City of Portland Design Commission

Design Advice Request

SUMMARY MEMO

Date: October 8, 2021
To: Leslie Cliffe, BORA Architects
From: Hannah Bryant, Design Review
503.865.6520 | Hannah.Bryant@portlandoregon.gov
Re: EA 20-216759 DAR – 1325 NW Kearney | Welby
Design Advice Request Commission Summary Memo – September 23, 2021

WELBY COLOR OPTIONS

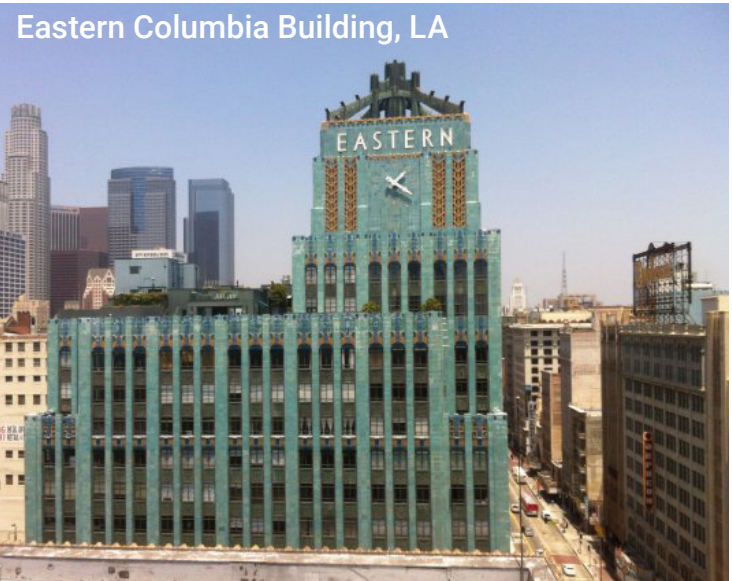
1. **Exterior materials.** Strong support for the color, provided the building is very well detailed, with lots of articulation, and some contrasting color/material. The distinctive color will not be successful if the necessary detailing and articulation are value engineered out of the final construction or if the color appears flat.
2. **Rooftop Screening.** Screening around the entire roof edge is a strong move.
3. **Quality.** Metal panel needs to be a heavy gauge to avoid oil-canning, denting or waviness.
4. **Concrete Base.** The concrete base is working well, and the height is sufficient. The height should not be reduced in future iterations.
5. **Glass.** It is critical that the glass does not appear green and is not reflective. The clear, non-reflective glass contrasting with the green metal cladding is what makes the green cladding successful.

WATER FEATURE OPTIONS

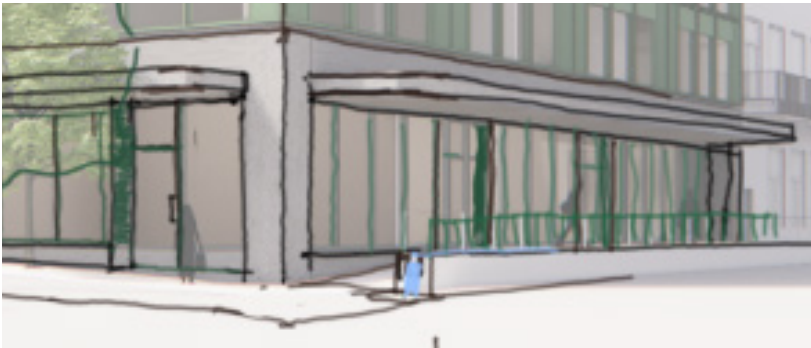
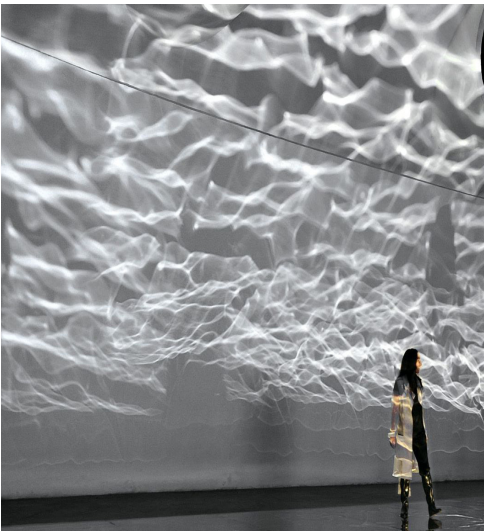
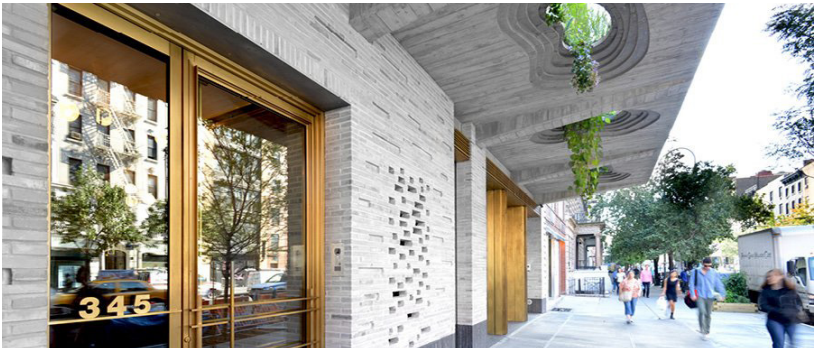
1. **Water Feature.** Commissioners support a water feature integrated with the loading dock if PBOT supports it.
2. **Art Feature.** Commissioners are open to an art element on the underside of the canopy, given that the proposal is built to the property lines and has no on-site space to locate an art feature outside the building. Notably, Commissioners are open to combining the water feature and the art feature, provided the single element is clearly responding to both of the Art and Water Feature guidelines. See the recently approved Hyatt hotel for an example of a recently approved project that combined art and water into a single element.

SOUTH ELEVATION

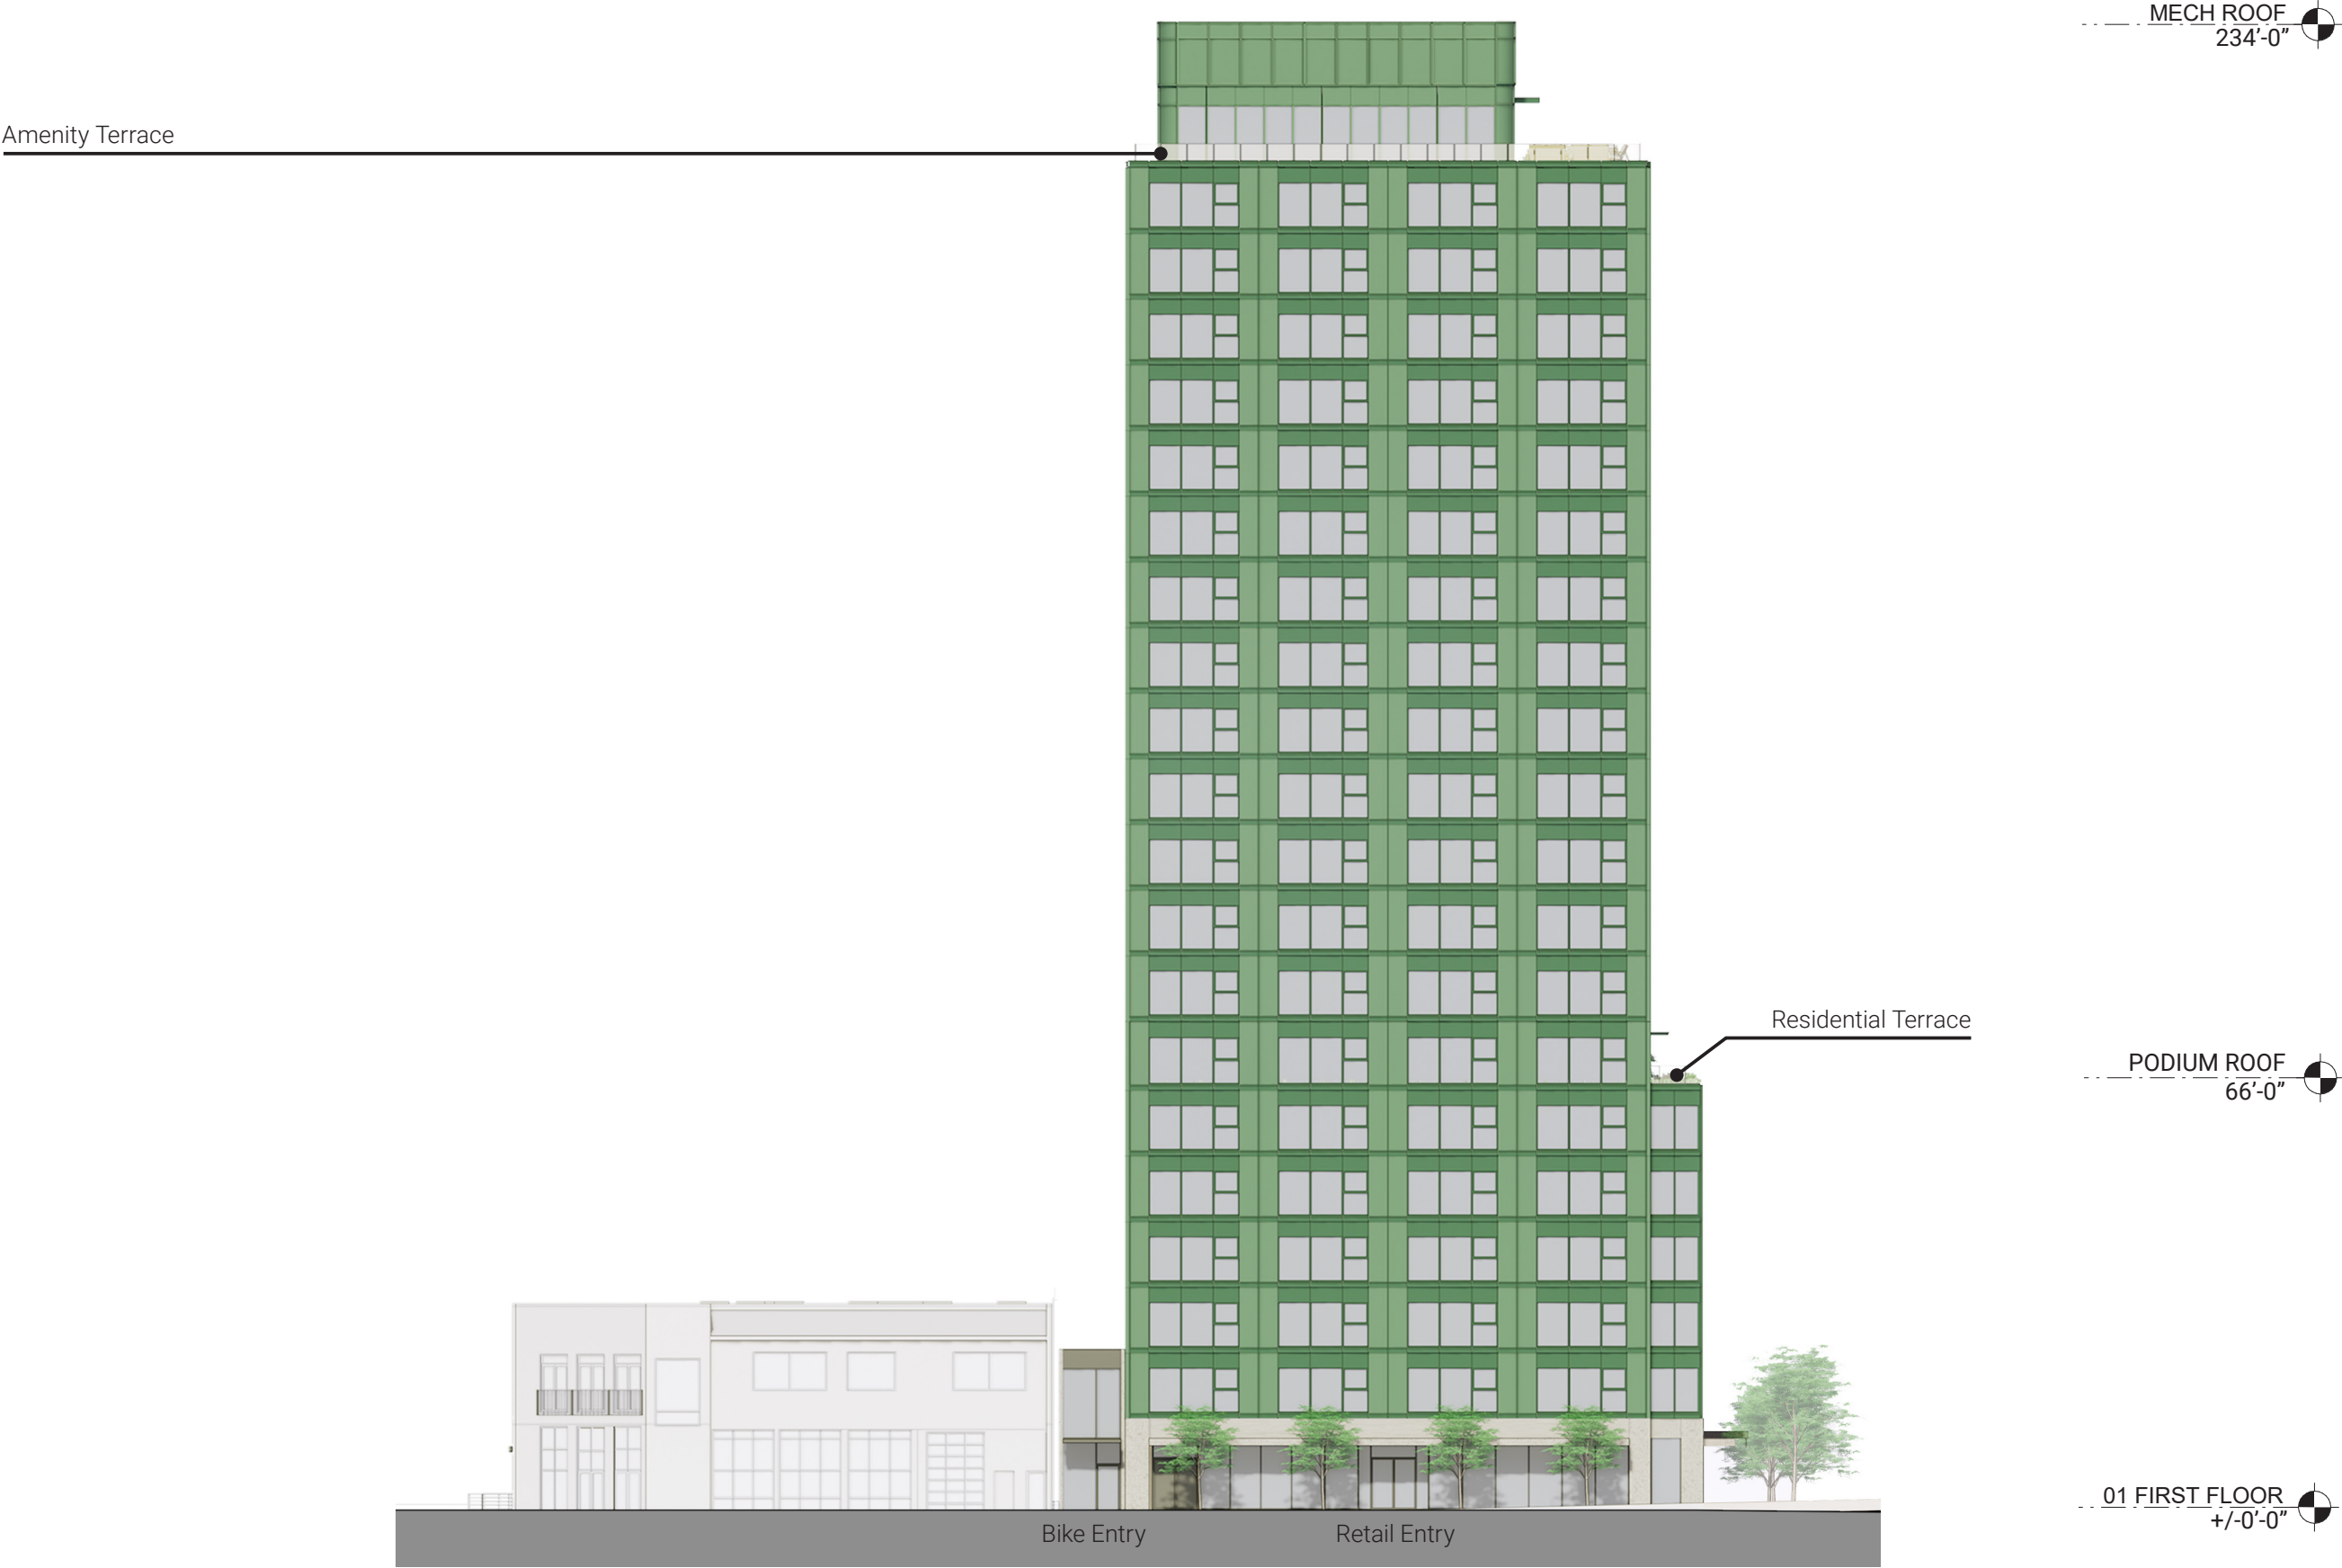
3. **Rooftop Mechanical.** *Upon careful consideration, staff supports the proposed rooftop mechanical screening. While elevations make this mechanical level appear quite tall, the perceived height will be less when viewed from the pedestrian realm. The proposed rooftop mechanical screening does not exceed the allowable height. Notably, the proposed perimeter screening is integrated with the architecture and fully encloses all rooftop mechanical and will allow for future reconfiguration and replacement without triggering additional design reviews. Staff questions whether a different color for this mechanical screening might be warranted to reduce its perceived bulk.*
